Economic Commission for Europe**Inland Transport Committee****World Forum for Harmonization of Vehicle Regulations****Working Party on Noise and Tyres****Seventieth session**

UN Regulation No. 51 (Noise of M and N categories of vehicles)**Proposal for Supplement 6 to the 03 series of amendments to
UN Regulation No. 51 (Noise of M and N categories of
vehicles)****Submitted by the Informal Working Group on Additional Sound
Emission Provisions (IWG ASEP)***

"Figure 4a

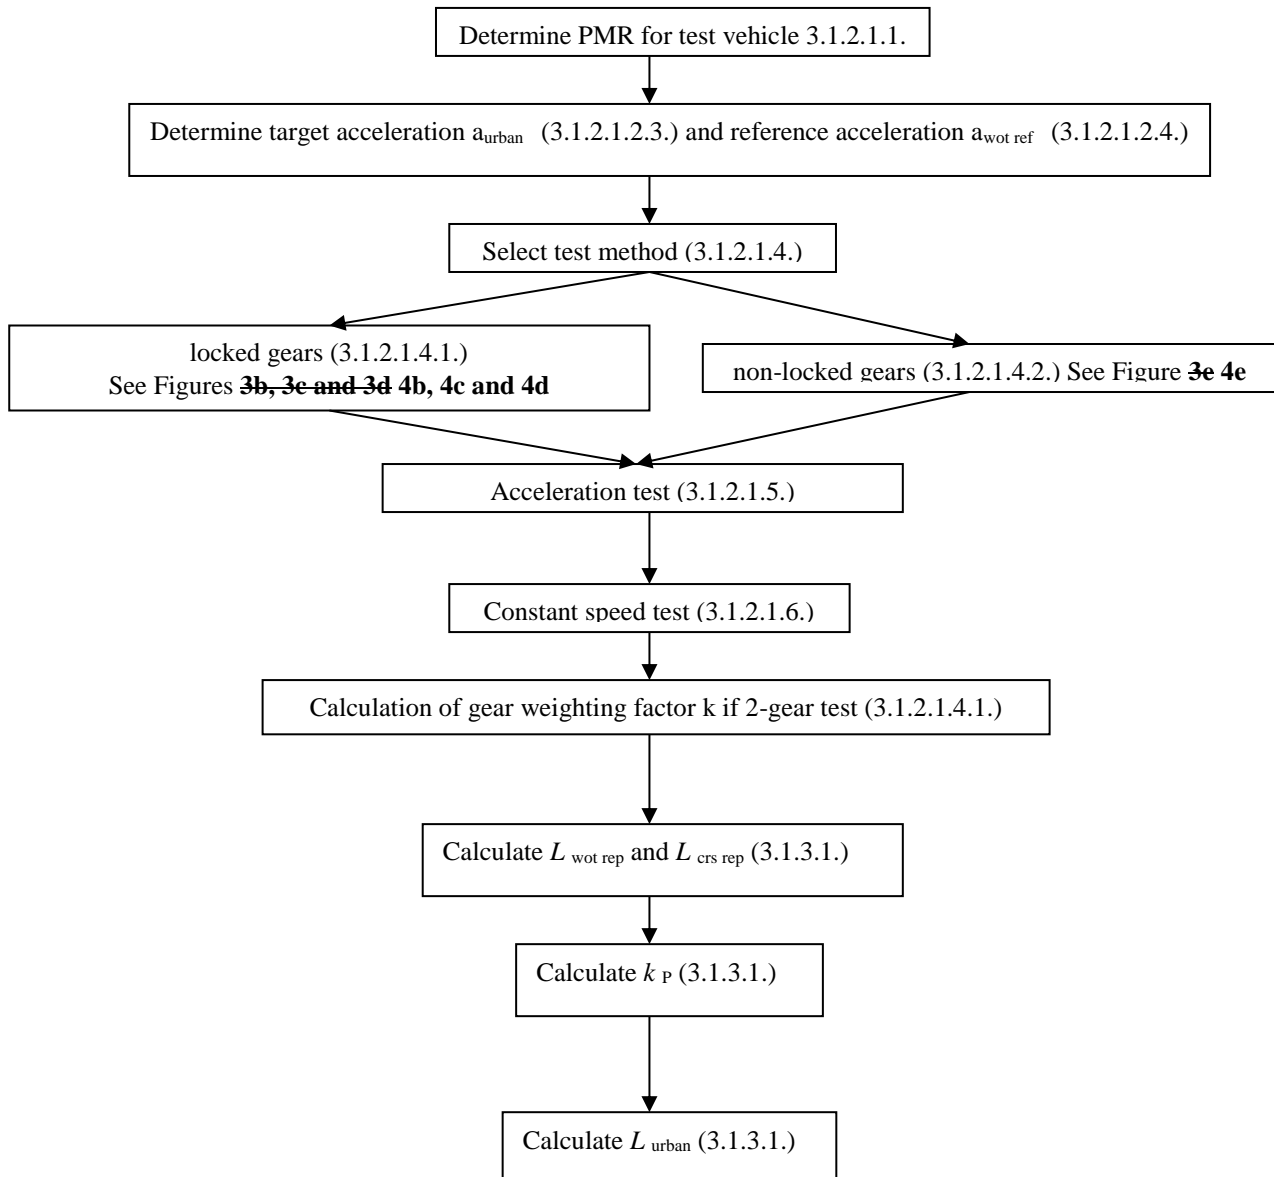
Figure 4a, amend to read

Flowchart for vehicles tested according to paragraph 3.1.2.1. of Annex 3 to this Regulation
– ~~L_{urban}~~-L_{urban} computation

12. The following modifications have been made: for Figure 4a - correction of references; for Figure 4b - reference for stable acceleration was added; for Figure 6 - the flowchart for stationary sound was added for more clarity.

"Figure 4b

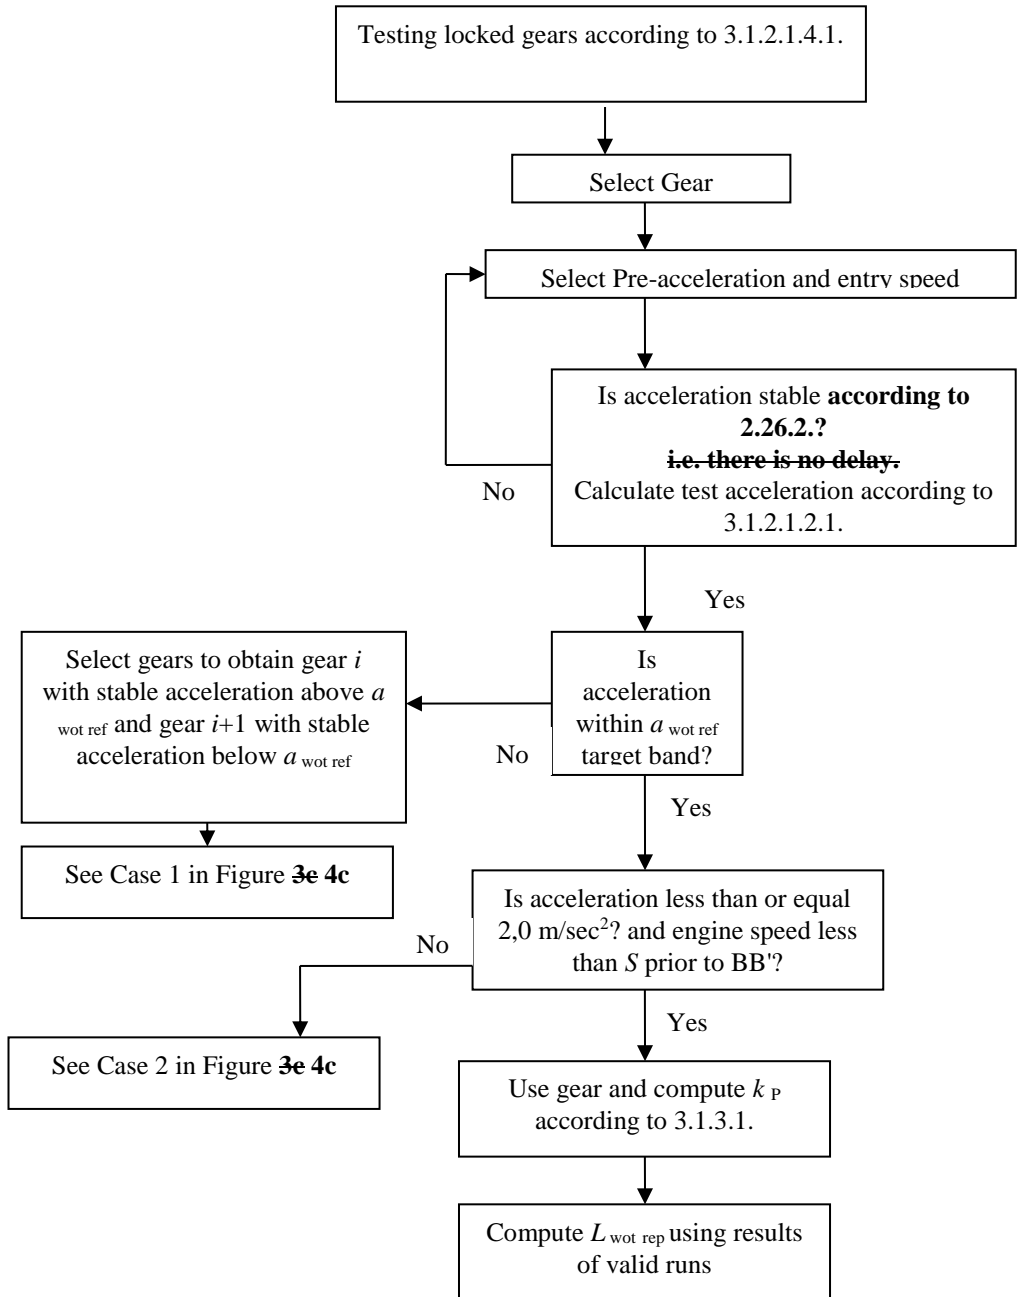
Figure 4b, amend to read

Flowchart for vehicles tested according to paragraph 3.1.2.1. of Annex 3 to this Regulation
 - Gear selection using locked gear. PART 1

5. Clarification was added according to the new definitions for stable acceleration

"Figure 6

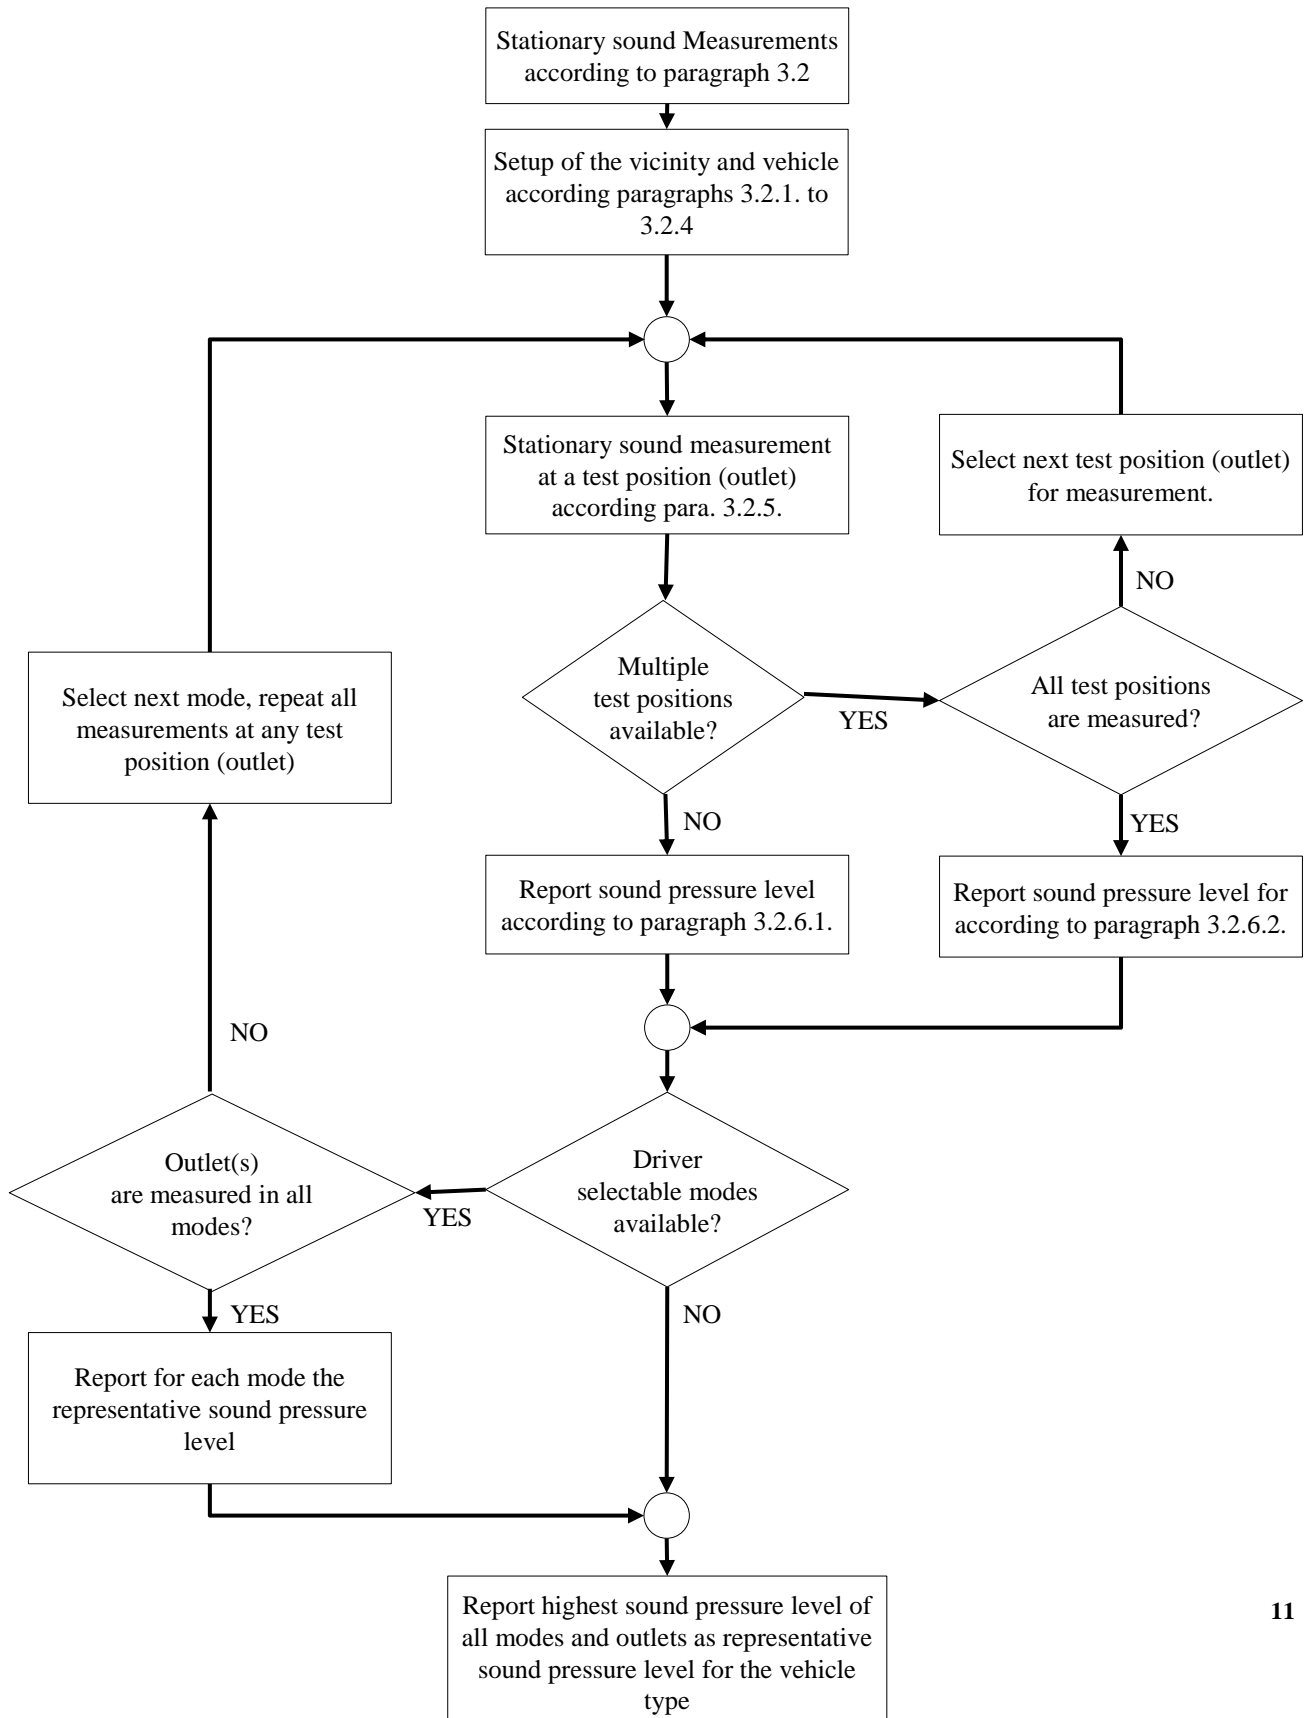
Add a new figure 6:

Flowchart for measurement and data processing of stationary sound according to paragraph 3.2.
